A4LD UPDATE HANDBOOK INDEX

FORD A4LD

"UPDATE HANDBOOK"

Figure 34

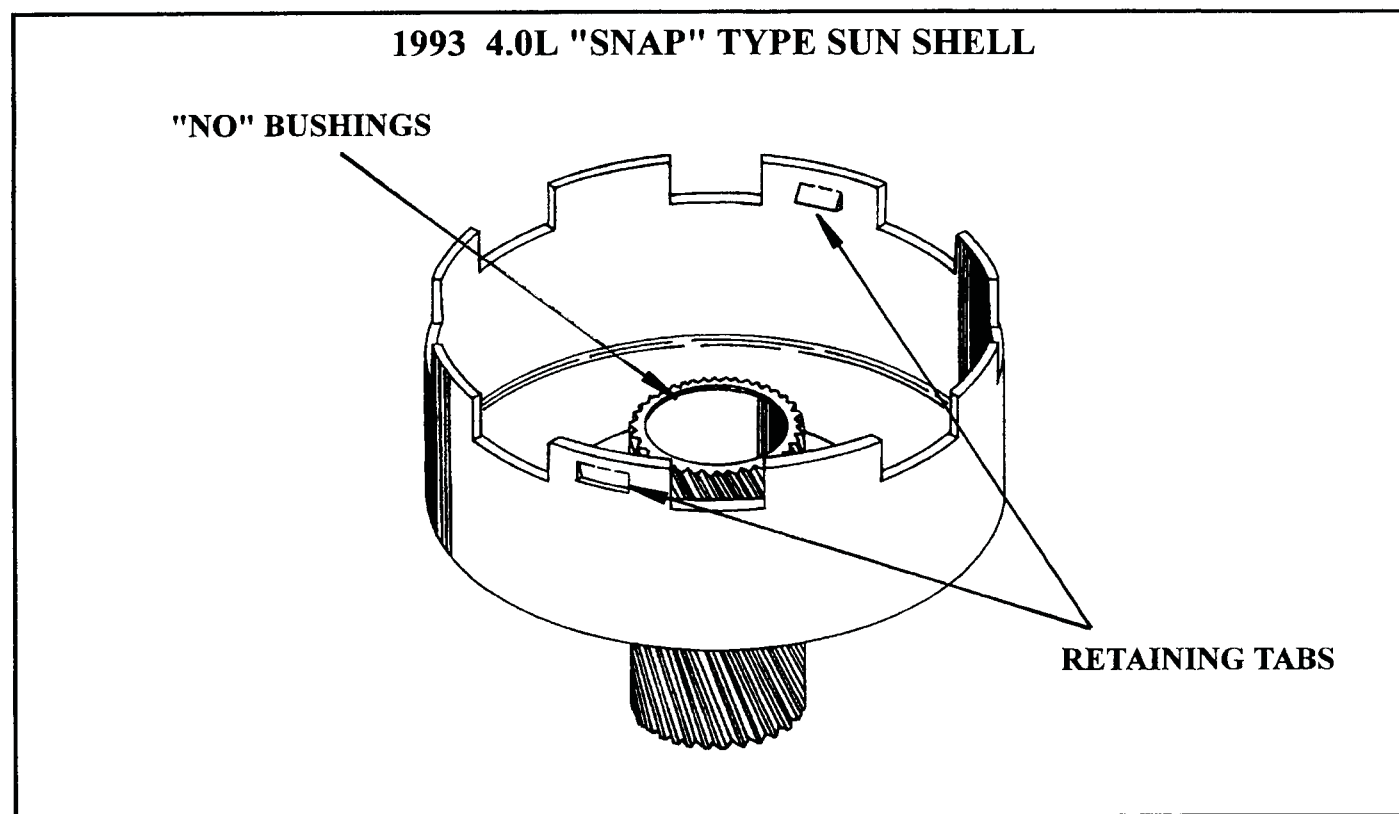
(3) **SUN GEAR SHELL** - "Snap Shell" was introduced in 1993 4.0L models, and has two retaining tabs stamped into the sides 180° apart, as shown in Figure 34. These tabs are used to retain the new direct clutch drum in the sun gear shell. The flat steel thrust washer (No. 14) on the back side of sun gear shell was eliminated when the sun gear bushings were eliminated.

Figure 35

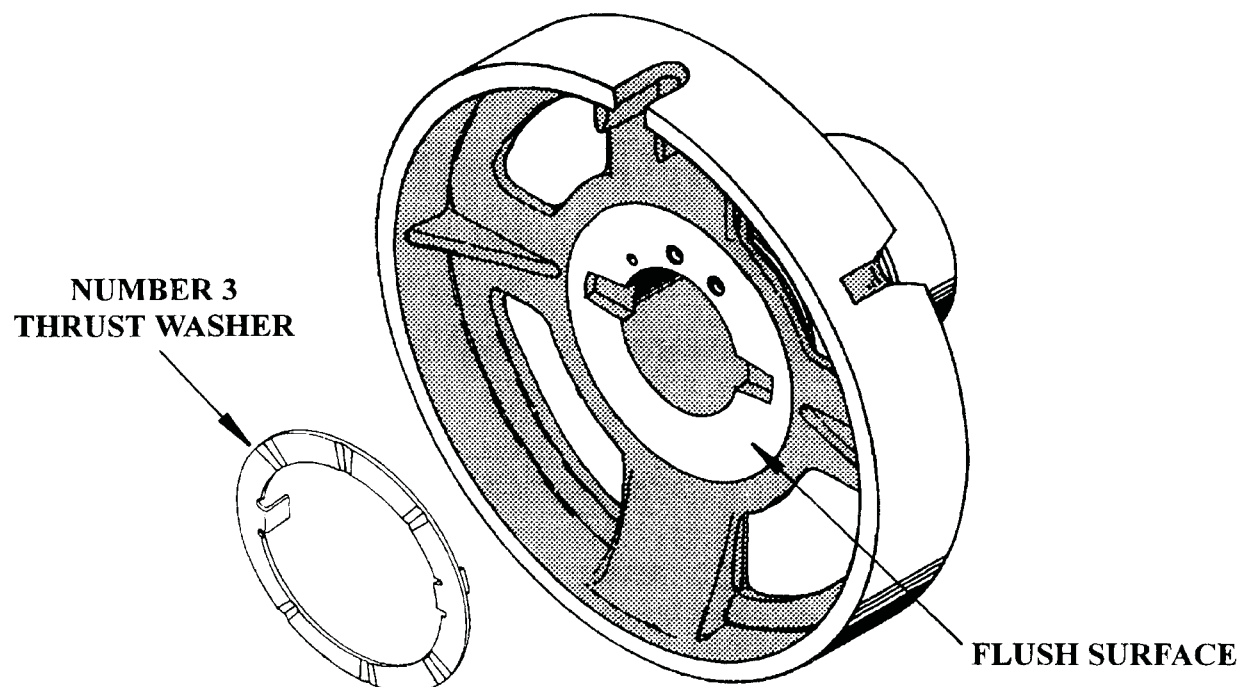
(4) **CENTER SUPPORT** - When the "Snap Shell" was introduced in 1993, the number 3 thrust washer was eliminated (See Figure 35), & number 3 thrust bearing was added (See Figure 36). The addition of the number 3 thrust bearing required machining the surface deeper to accommodate the bearings added thickness (See Figure 36).
The new design center support also has a machined recess at the base of the sealing ring hub to accommodate the newly added number 5 thrust bearing (See Figure 38). Remember, the number 4 thrust washer was eliminated when this change occurred (See Figure 37).

- (6) The previous design center support **CANNOT** be used forward into **ANY** model that is using the "Snap Shell" (See Figure 35).
- (7) The new design forward clutch drum **WILL** retro-fit back on **ALL** previous models. (See Figure 39).

Figure 36

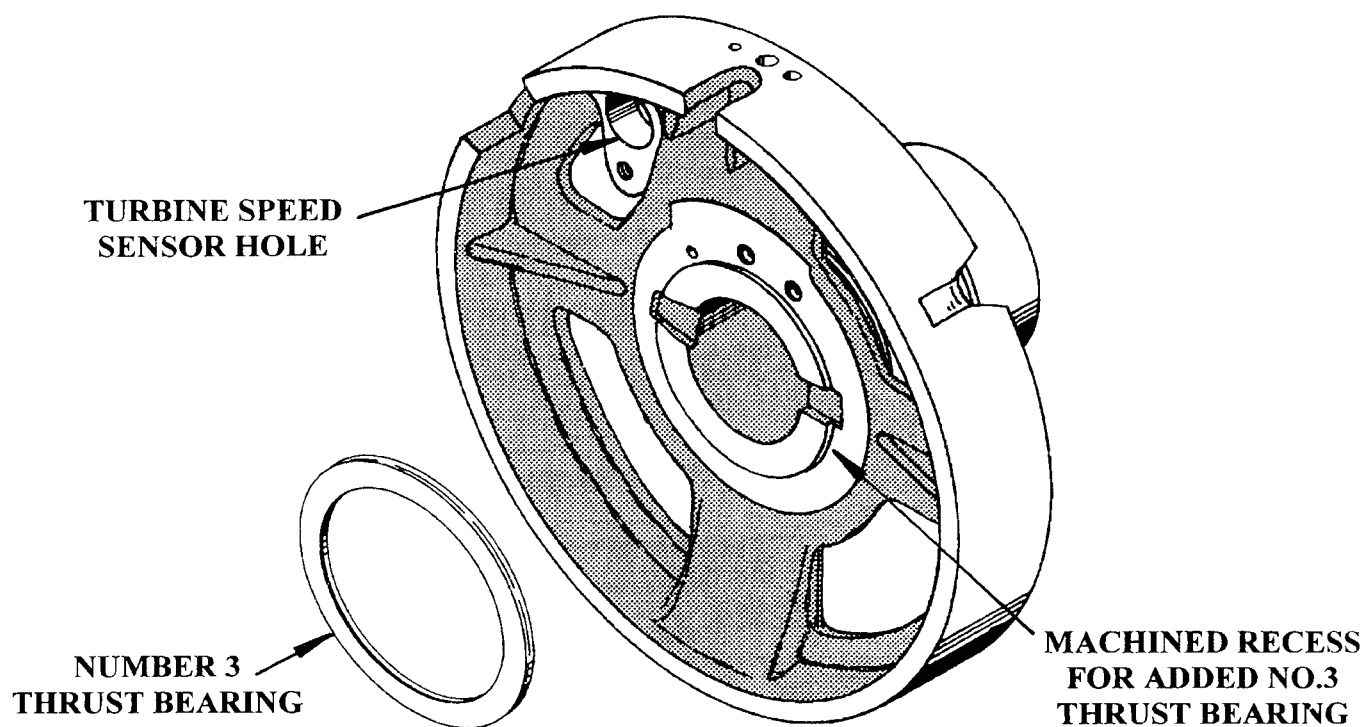
1. Machined recess for added number 3 thrust bearing (See Figure 36).
2. Machined recess for added number 5 thrust bearing (See Figure 38).
3. Machined hole for turbine speed sensor getting ready for 4R55E (See Figures 36 and 38).
NOTE: Some new design center supports are cast for, but no hole has been machined.
4. Casting number on new design center support is 92GT-7L328-AA.

Figure 39

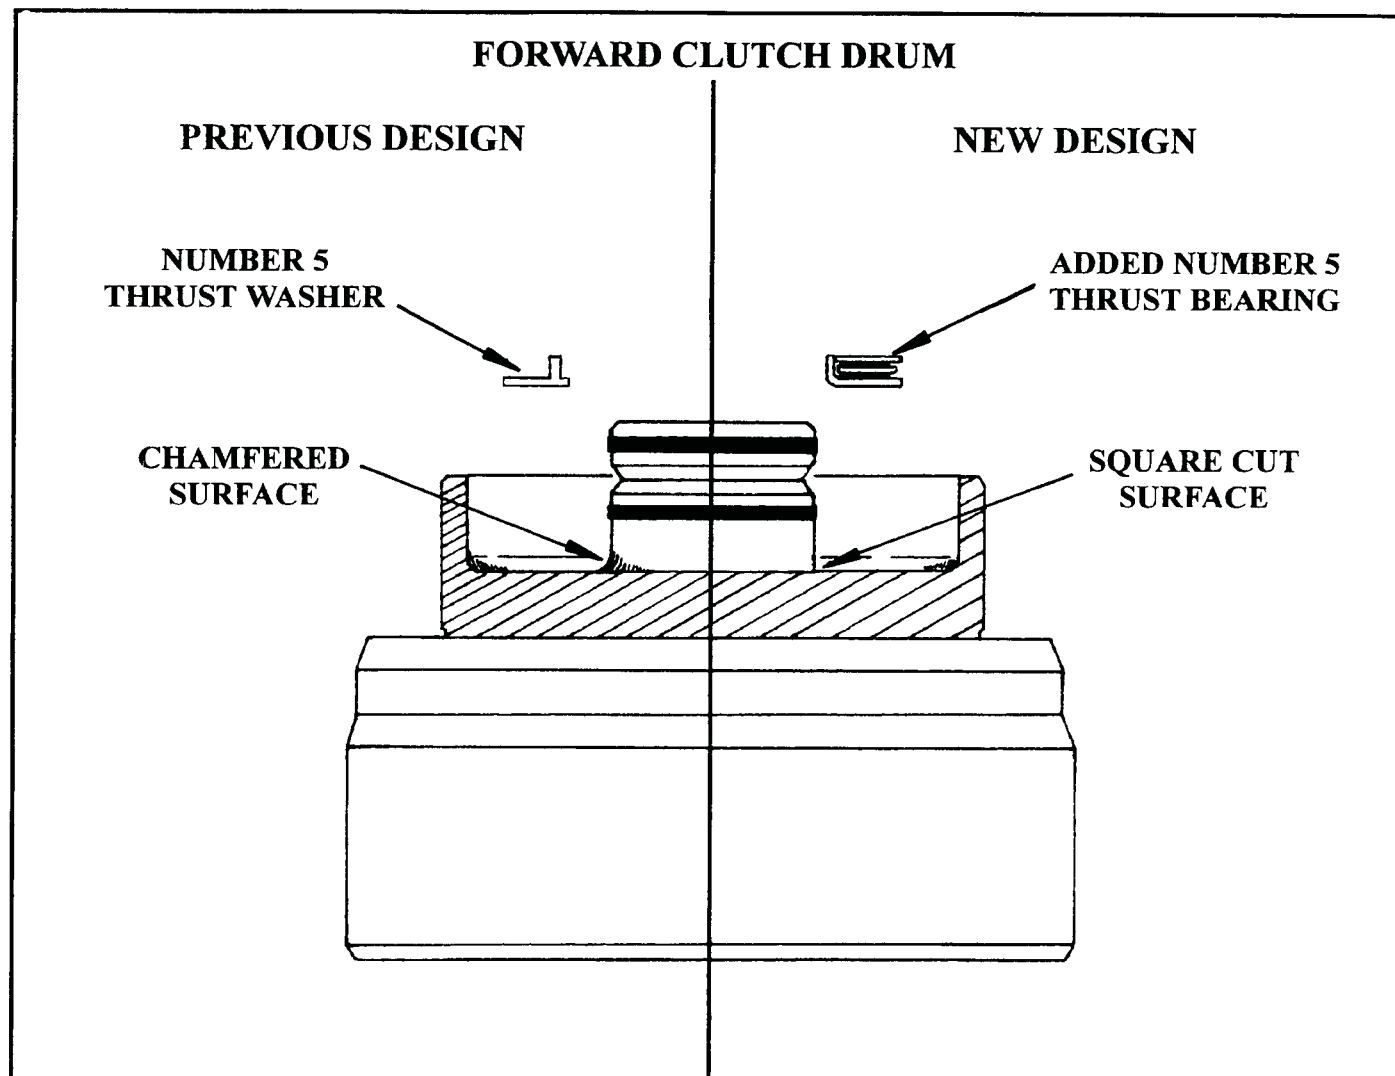
(5) **FORWARD CLUTCH DRUM** - Was machined at the base of the sealing ring hub to eliminate the chamfer, and provide a flat surface to accommodate the added number 5 thrust bearing, as shown in Figure 39.

- (8) The previous design forward clutch drum **CANNOT** be used in 1993 and later models, as the chamfered area at the base of the hub will not let the number 5 bearing seat properly (See Figure 39).

Figure 40

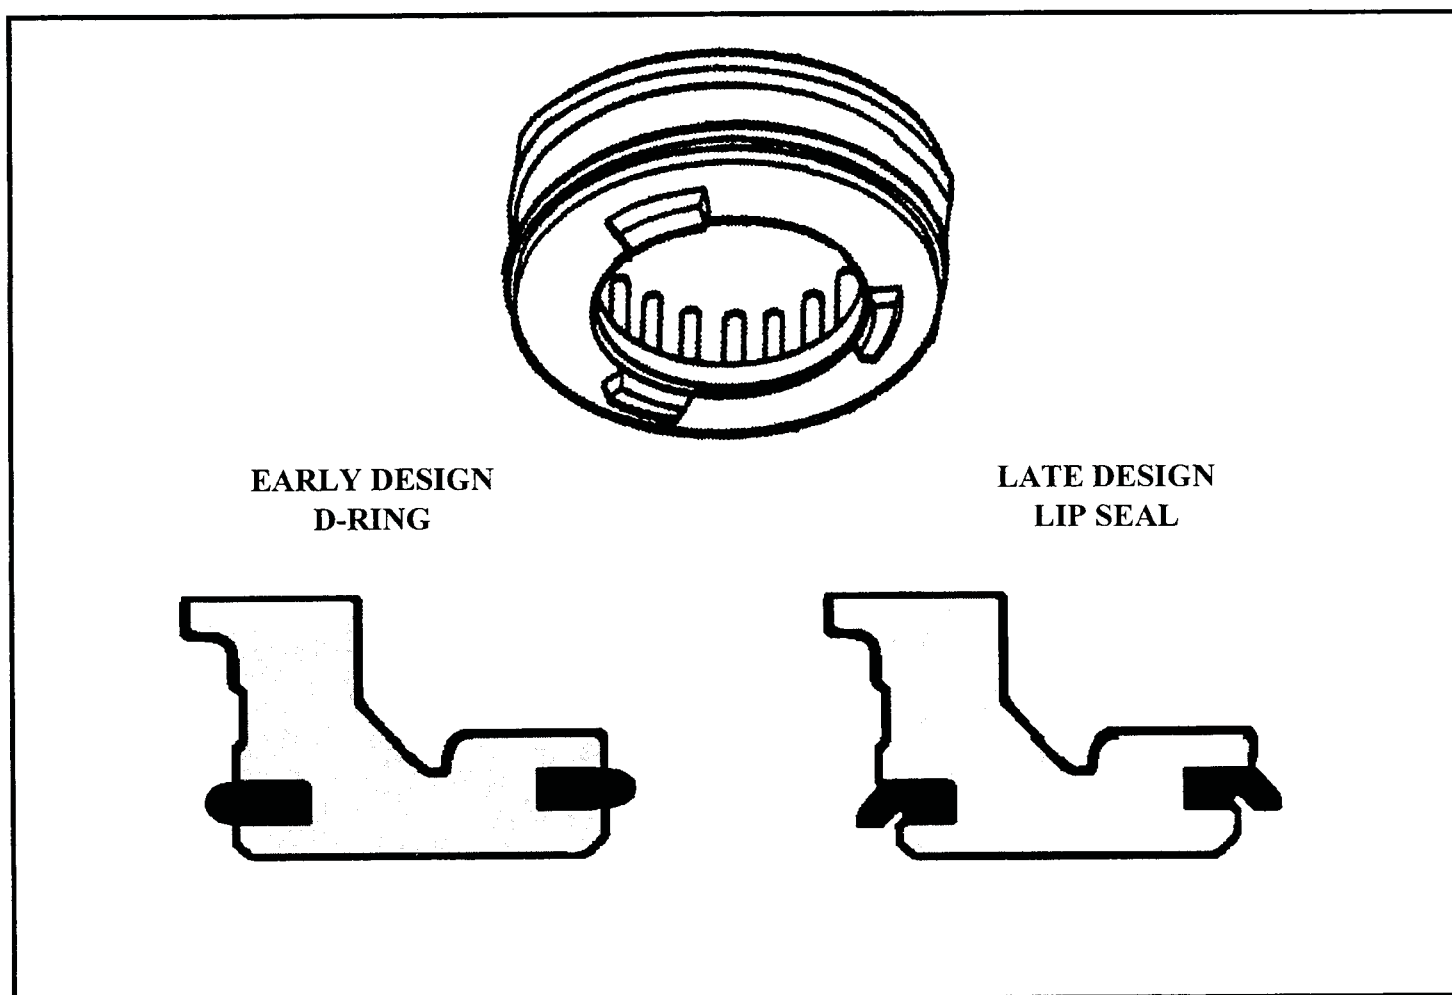
CHANGE: Both the overrun clutch and direct clutch piston seals were changed in 1987 from "D"-ring seals to lip seals (See Figure 40).

Although the early design "D"-ring & piston will interchange, we recommend using the later design lip seal, which requires changing the piston.

Figure 44

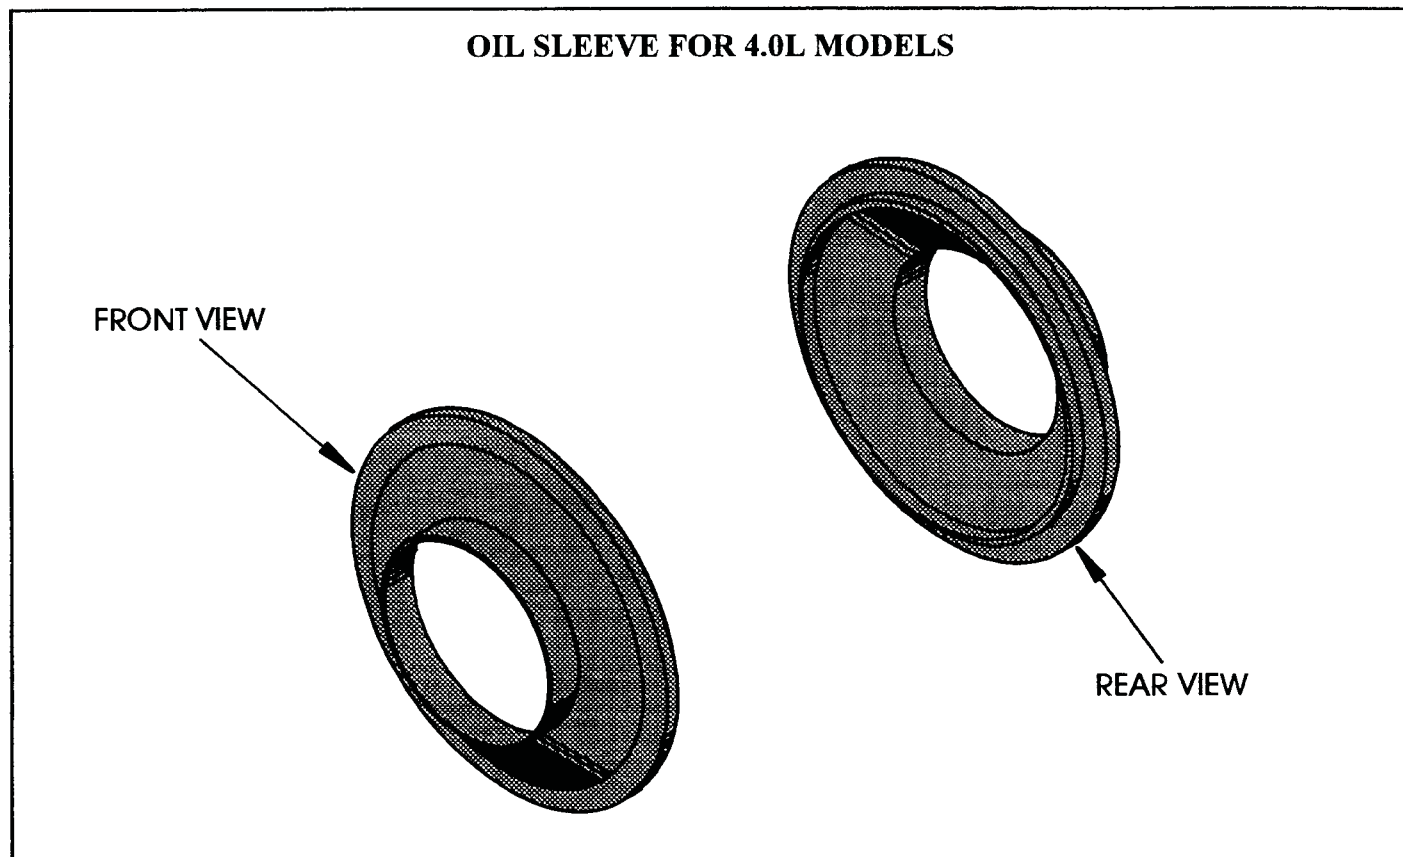
- (7) OIL SLEEVE - An added oil delivery sleeve, or lubrication guide, was added to the output shaft rear ring gear hub to direct lube oil from the added grooves in the hub, through the sun gear to the front planetary gear set (See Figures 44 and 47).

Figure 47

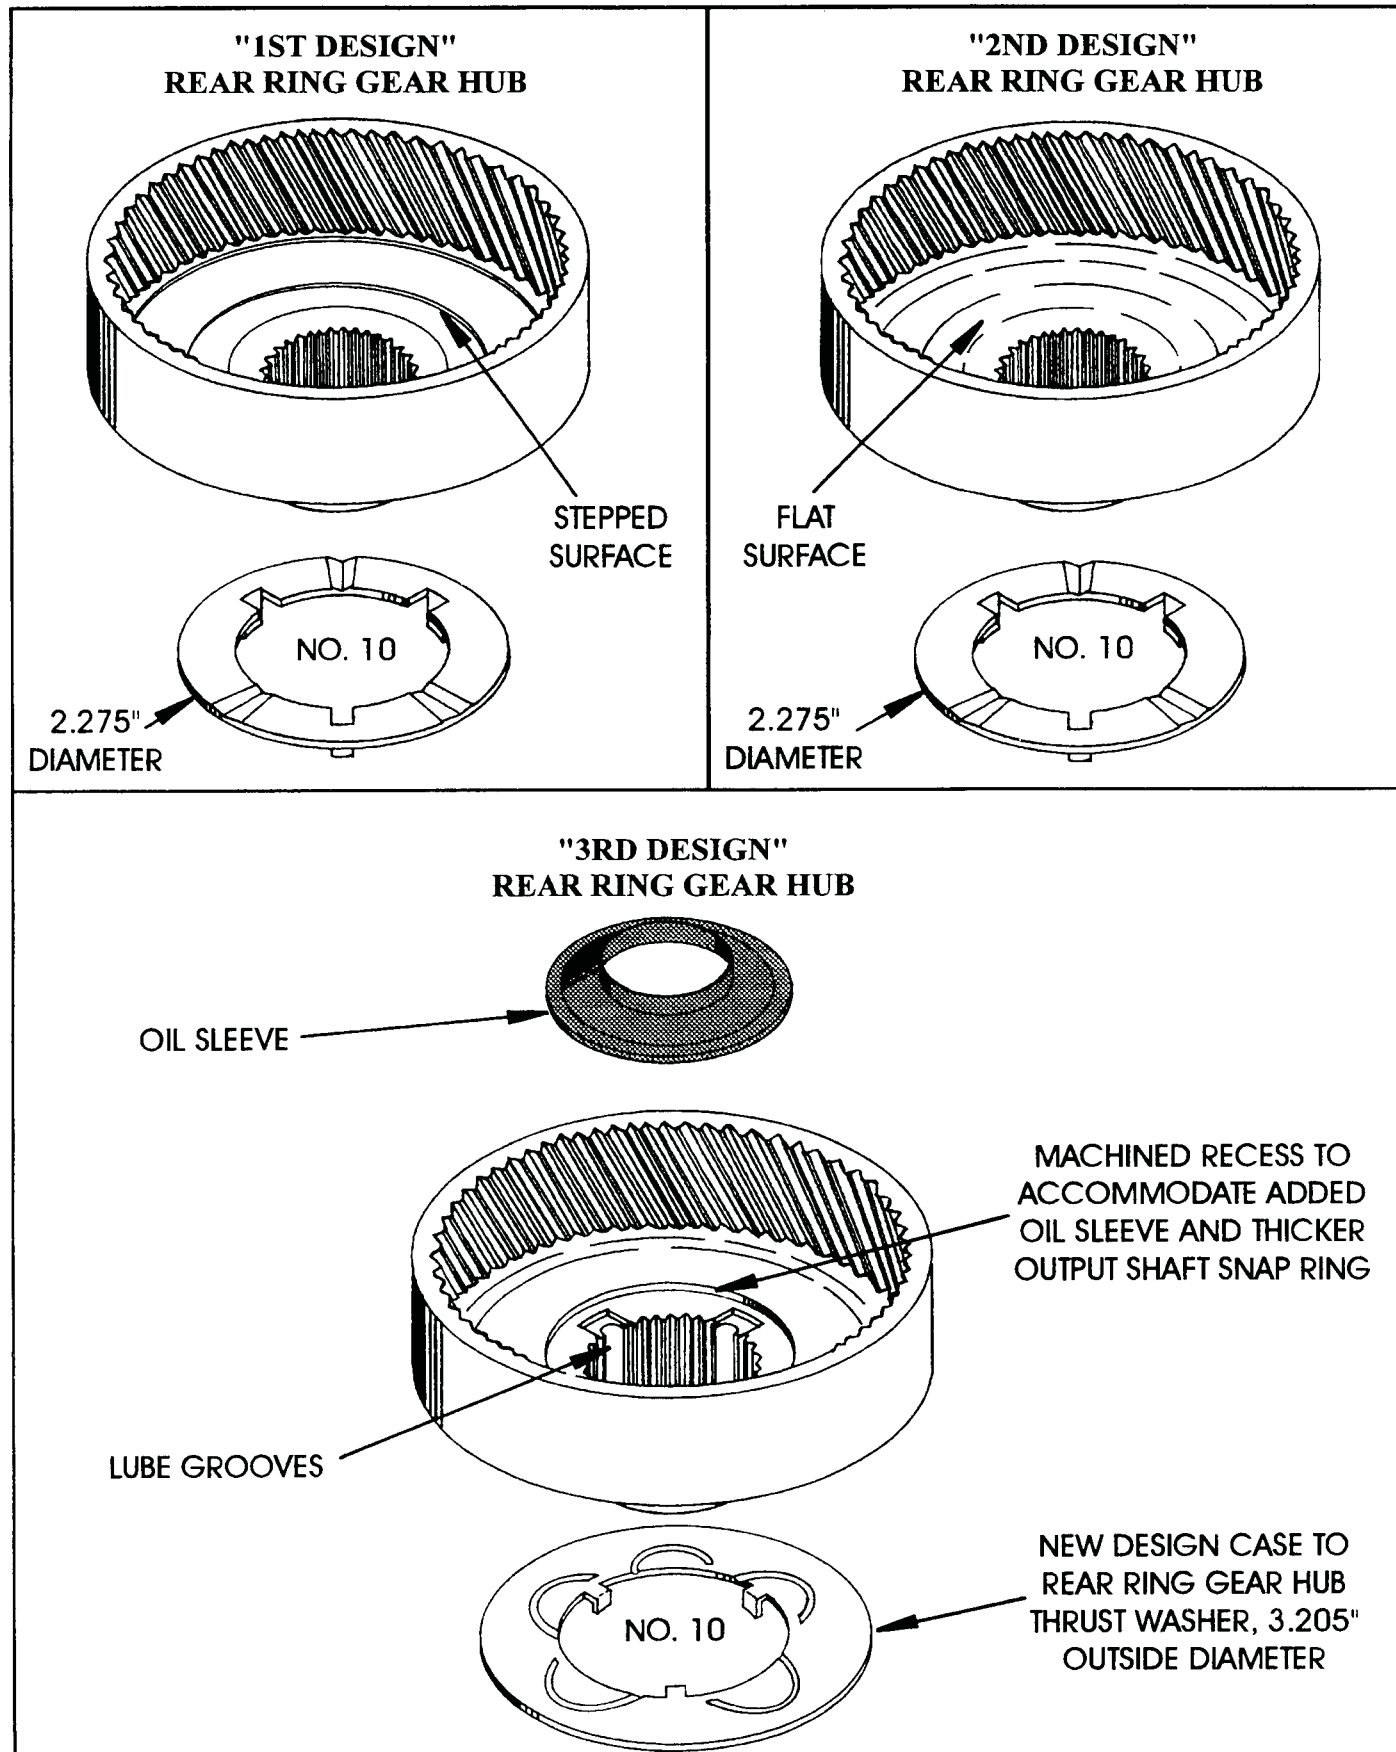
- (3) **REAR RING GEAR HUB** - The 1st design Rear Ring Gear Hub is identified with a "Stepped" washer surface as shown in Figure 47, and uses the 1st design number 9 thrust washer as shown in Figure 45. The 2nd design Rear Ring Gear Hub is identified with a "Flat" washer surface as shown in Figure 47, to accommodate the new 2nd design number 9 thrust washer (See Figure 45). The 3rd design Rear Ring Gear Hub is identified with a machined recess to accommodate the added oil sleeve and the thicker output shaft snap ring, and you can also see the added lube grooves in the spline area to accommodate the internal lube flow changes (See Figure 47). The 2nd & 3rd design Ring Gear Hub also has step removed out next to the ring gear teeth, to accommodate larger diameter of the 2nd design number 9 thrust washer (See Figure 47).

- (6) NUMBER 10 THRUST WASHER - Received a change in outside diameter (See Figure 47), and is now used to retain the low sprag end bearing on 4.0L engine models. Refer to the cutaway illustrations in Figure 49.
The outside diameter on the number 10 thrust washer for the 4 pinion carrier is 2.275", and the outside diameter on the number 10 thrust washer for the 6 pinion carrier is 3.205", as shown in Figure 47.
